Office Action Summary**Application No.**

10/537,596

Applicant(s)LINSSEN, PETRUS JOHANNES
ANTONIUS**Examiner**

**FIG. 5*****Allowable Subject Matter***

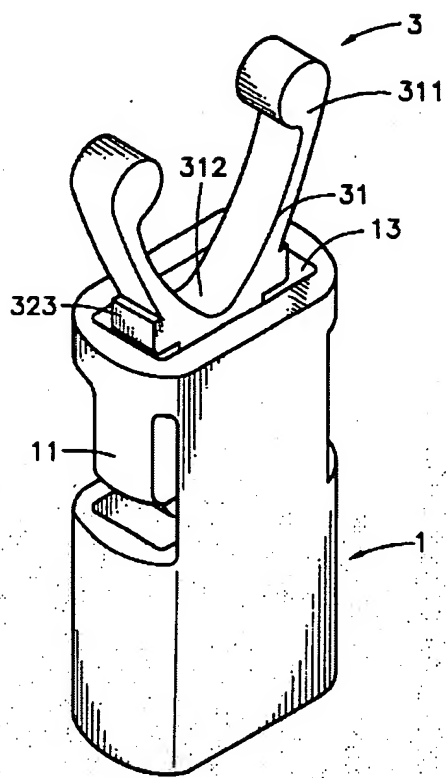
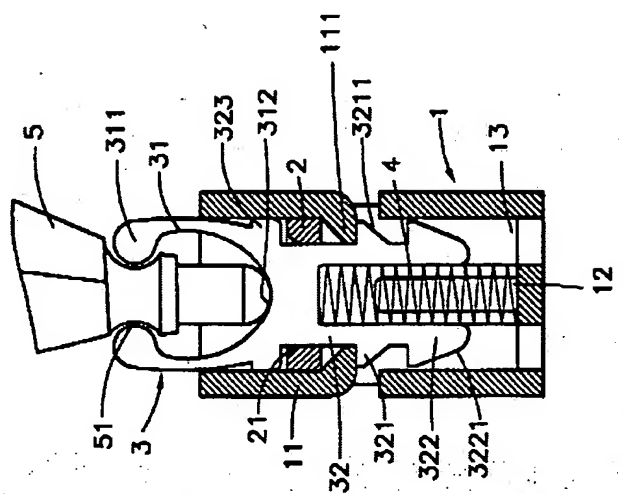
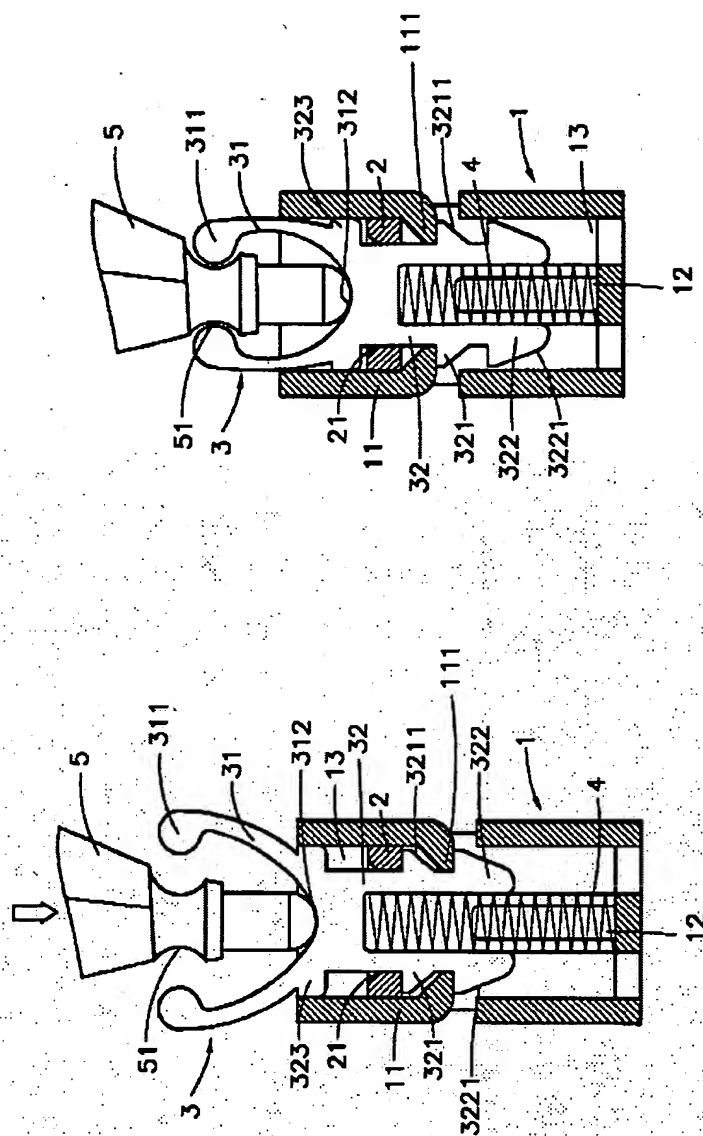
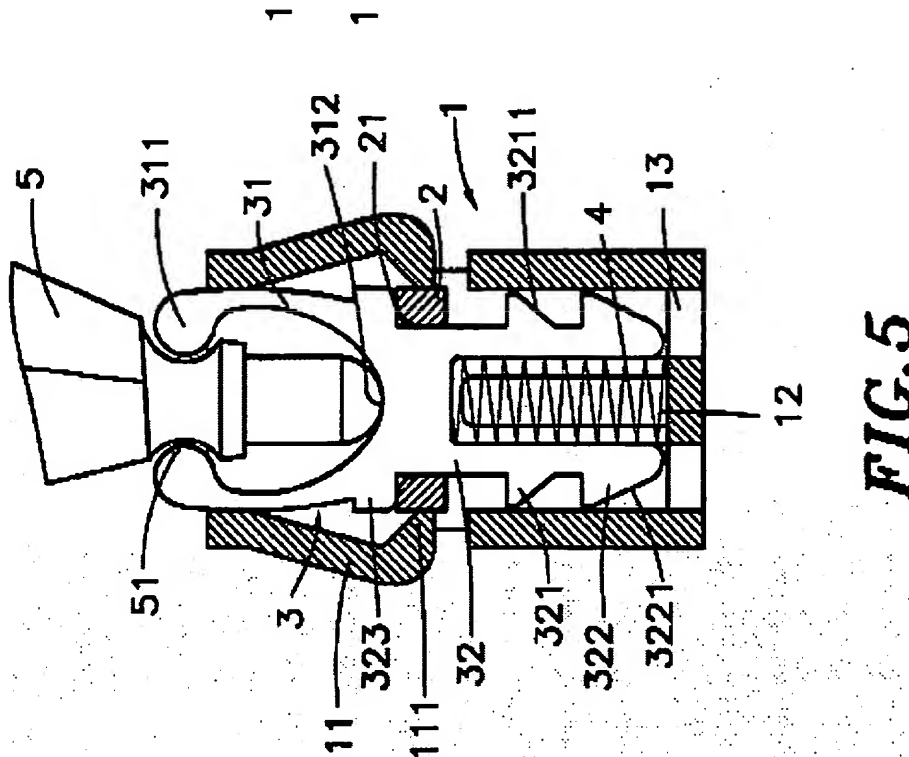
Claims 1,3,4,5,6,9 and 10 are rejected under 35 U.S.C. 102(a) as being anticipated by Lai et al.(US006386496). Referring to figures 3-5, Lai et al teaches a press-control retaining device, comprising a first portion(3) with a substantially flat button surface(312) that can be touched by a finger, and a second portion(1) connected by a spring means(4) with first catch means(31) that could engage a frame, the catch means comprising at least one elastically hinging catch element(see movement between figures 3 and 4) with the second portion(1) comprising guiding means(top of element 11) to push the catch means inward when the two portions are pushed together, against an increasing force from the spring element. The device further having

second catch means(321) that engage with corresponding catch means(111). Said second catch means comprise an elastically hinging catch element connected to the second portion(111), and the corresponding catch means comprise a fixed catch element(321) attached to the first portion. The device further comprising second spring means(11) that could abut a frame member placed adjacent the spring means, for pushing the second portion away from the frame. Looking to Fig 2 we see that the second portion(2) extends between two parallel planes(Front and back surfaces) where a substantial part of the surface of the device substantially coincides with said planes. With respect to claim 3, Lai states that his device is made from a "springy material"(C2 L49) which was assumed to be a plastic material, as well as metal spring(4) which is an elastic metal part.
